# CITY OF ALBUQUERQUE

**RE: DaVita Dialysis Center, 5207 San Mateo Blvd.  
Grading and Drainage Plan  
Plan Dated 4-20-15 (File: F17-D095A)**

Based upon the information provided in your submittal received 4-23-15, the above referenced plan is approved for DRB action on the Site Development Plan for Building Permit.

**C5.0**  
SHEET 9 OF 12

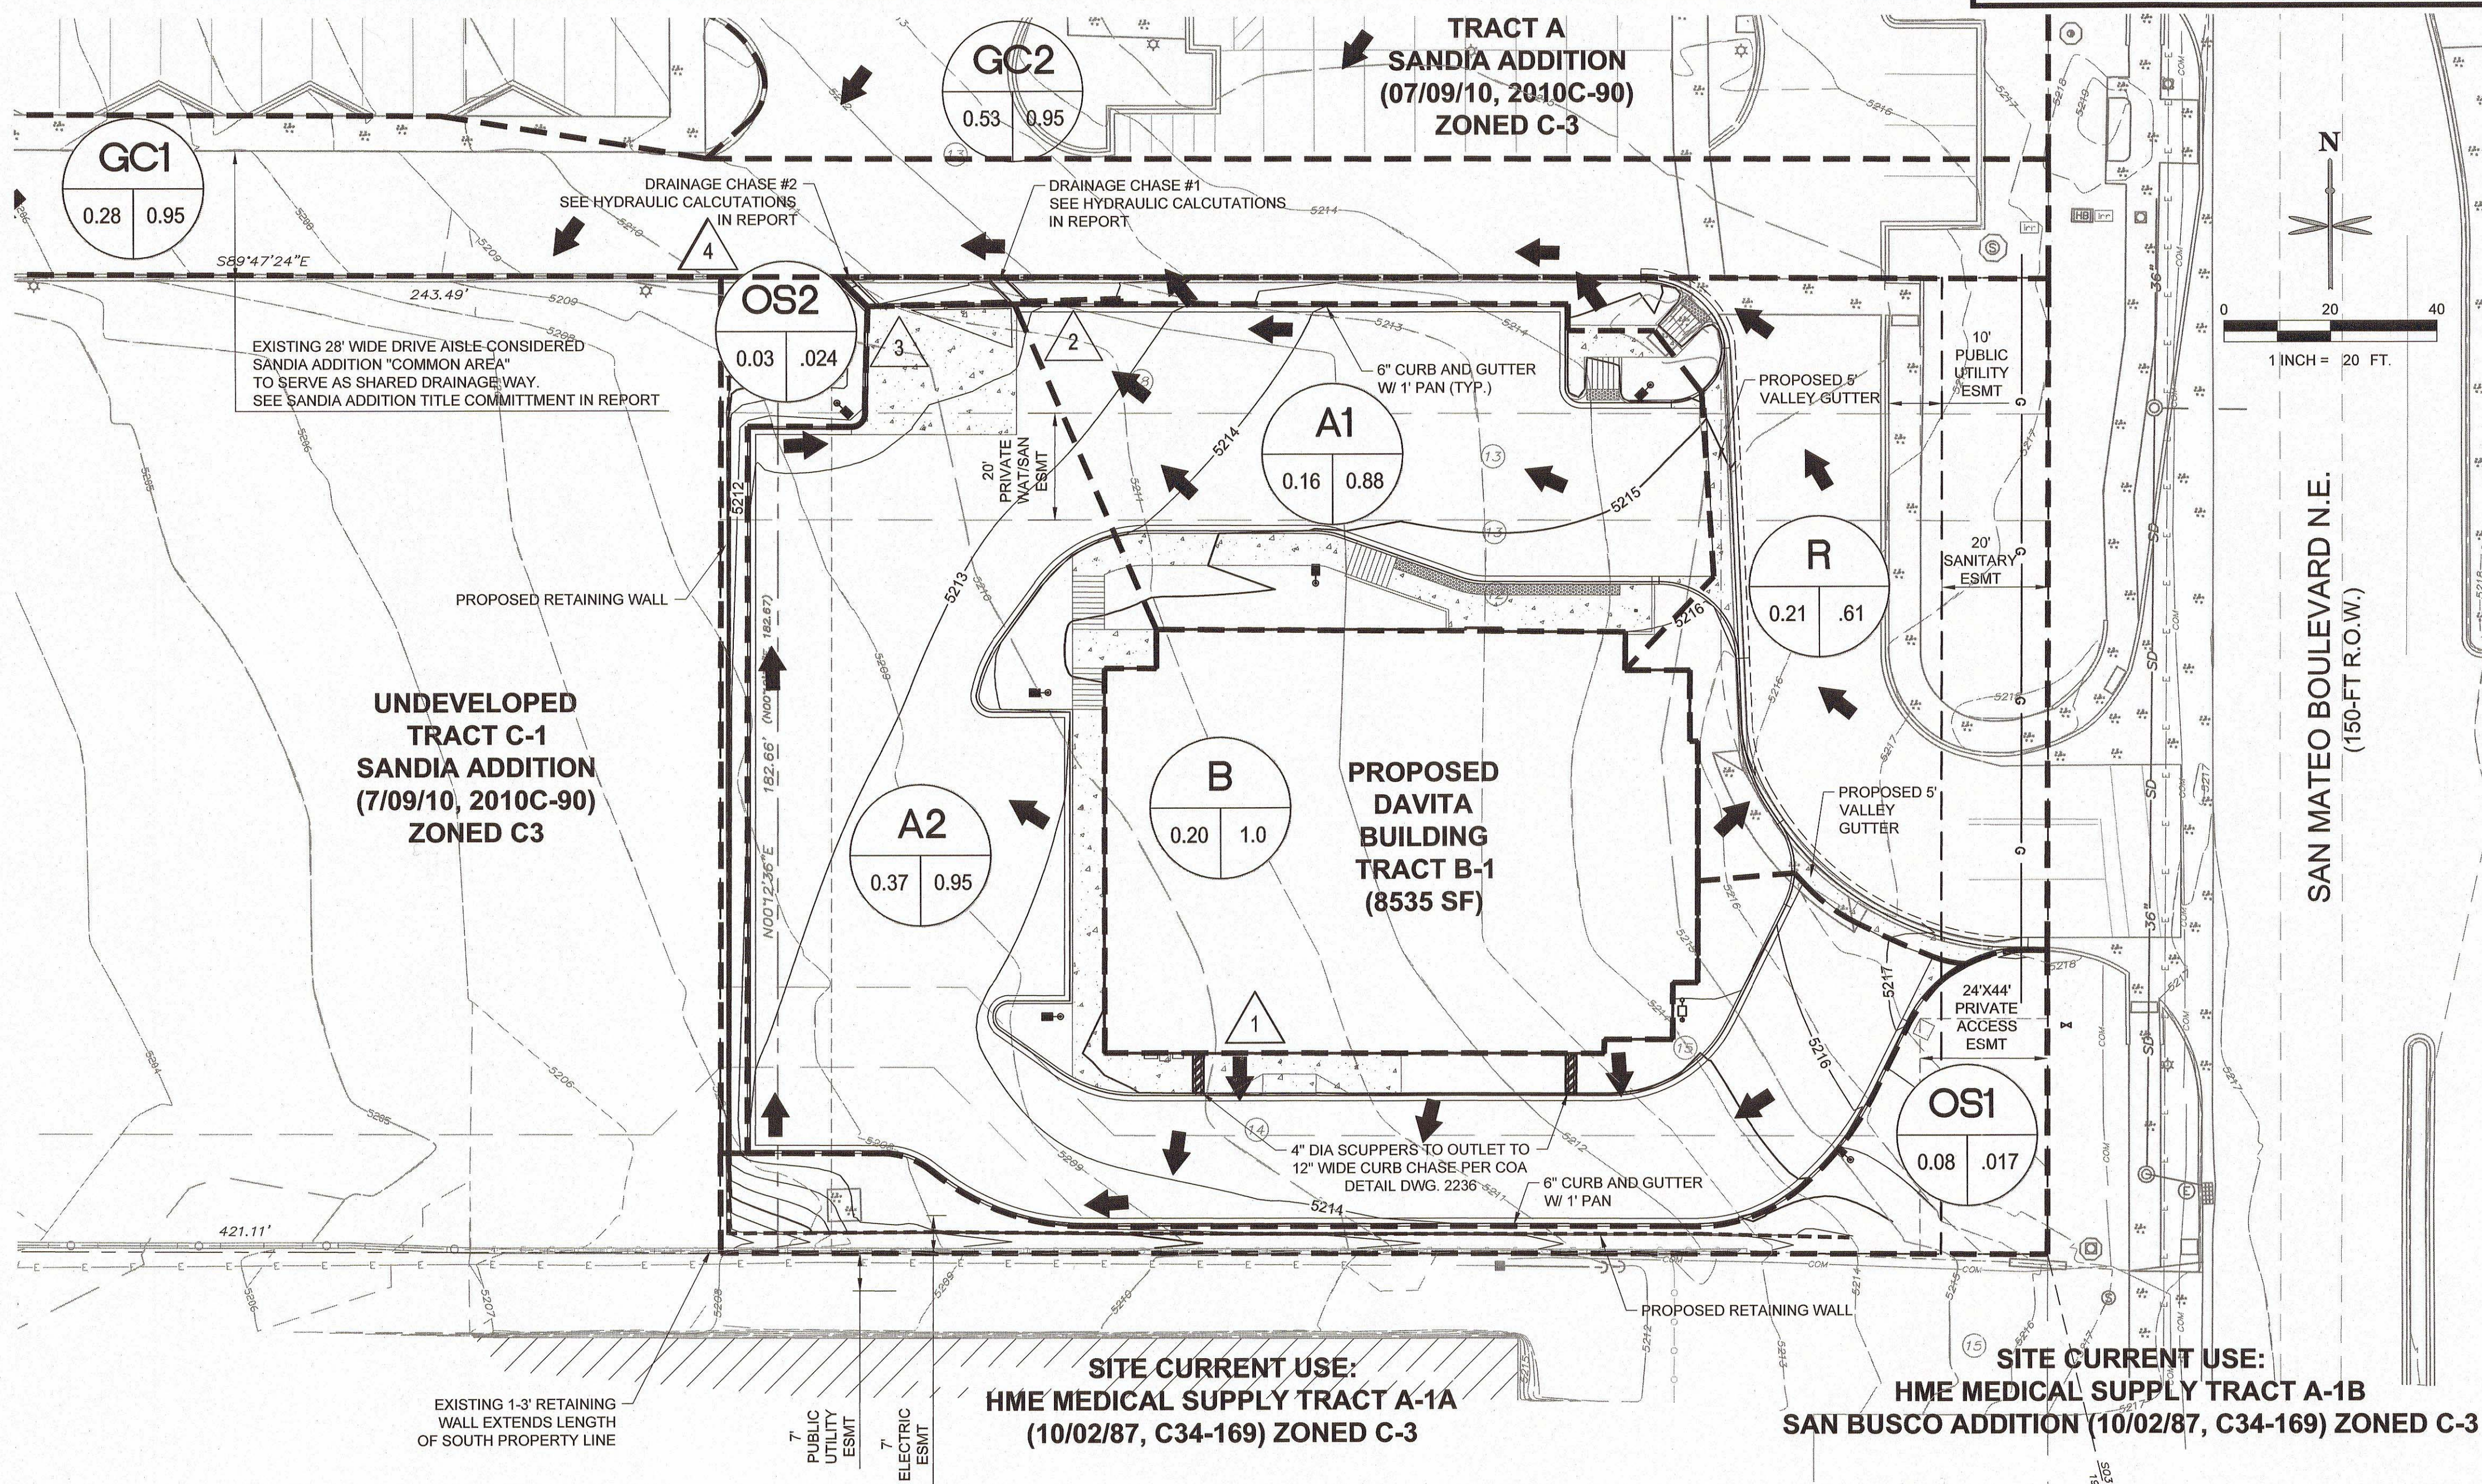
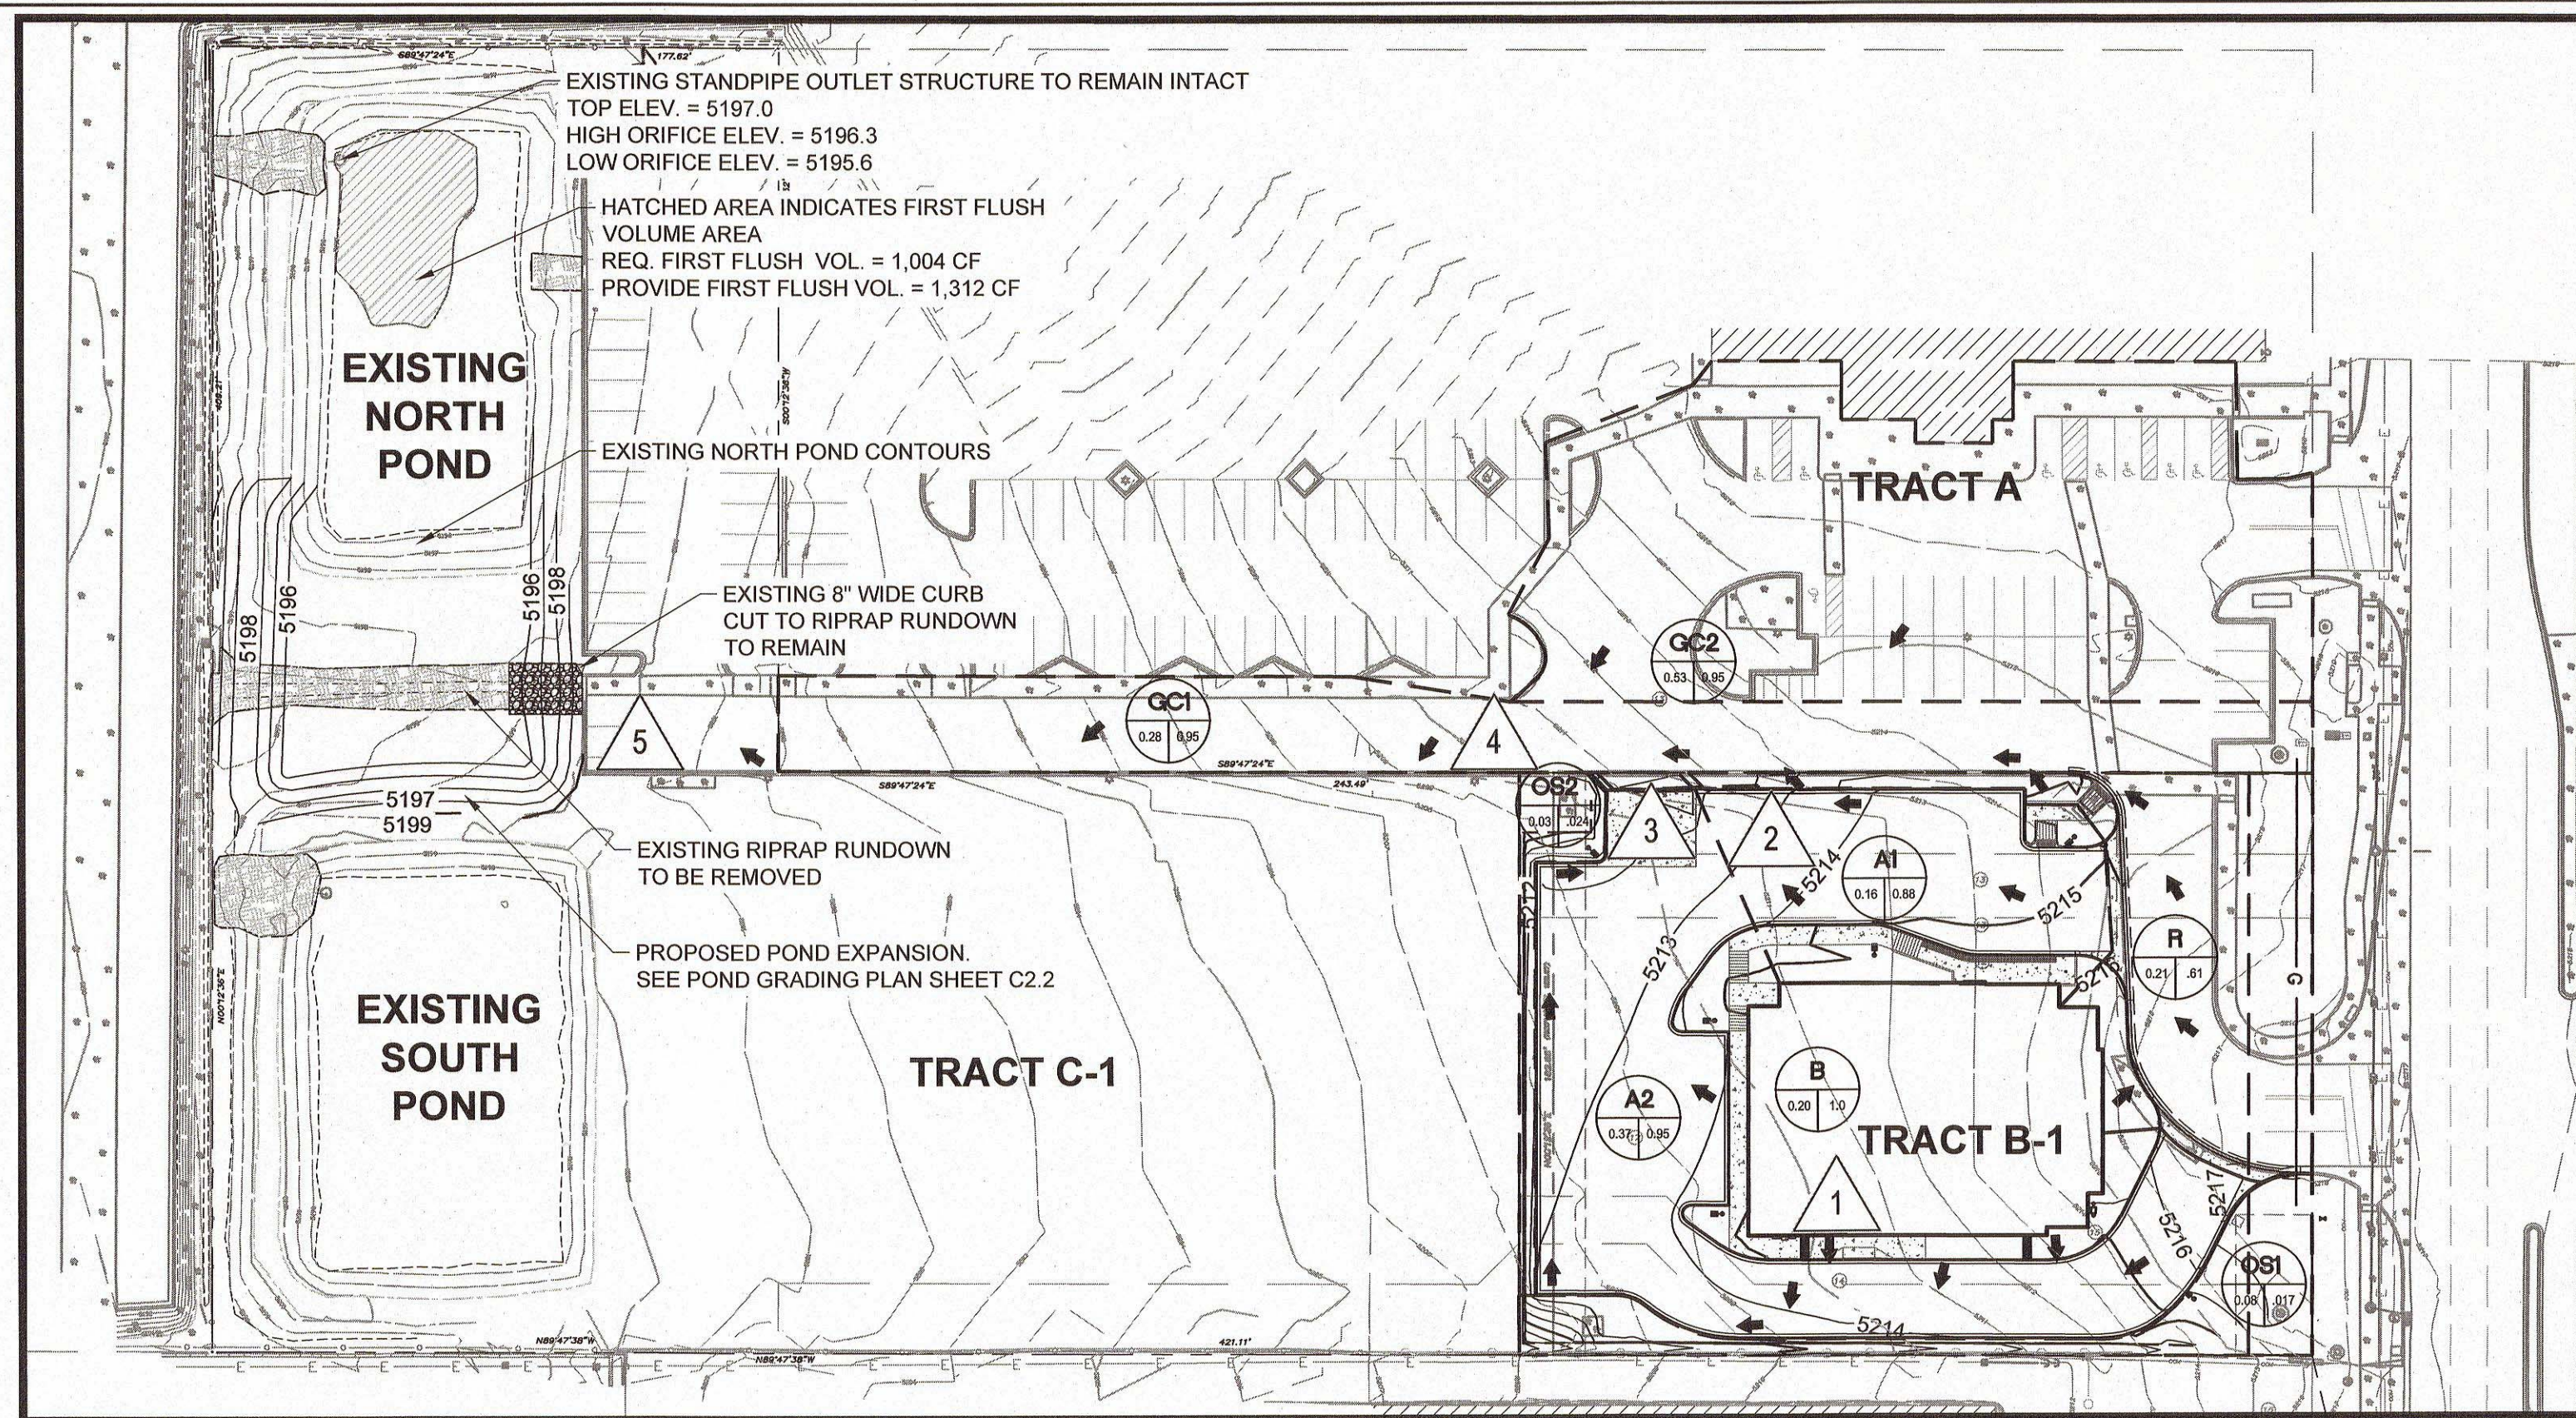
Prior to receiving approval on this project for Building Permit, please include all of the drainage calculations that you provided on 4/27/15 within the final drainage report. On the Sheet C5.0, include your computed WSEL for the 100-year-storm, the total volume provided for the storage pond, and the corresponding pond volume at the WSEL. Also, on Sheet C5.0, show all basins that contribute to the north pond which shall include all off-site stormwater runoff from the Golden Corral parking lot.
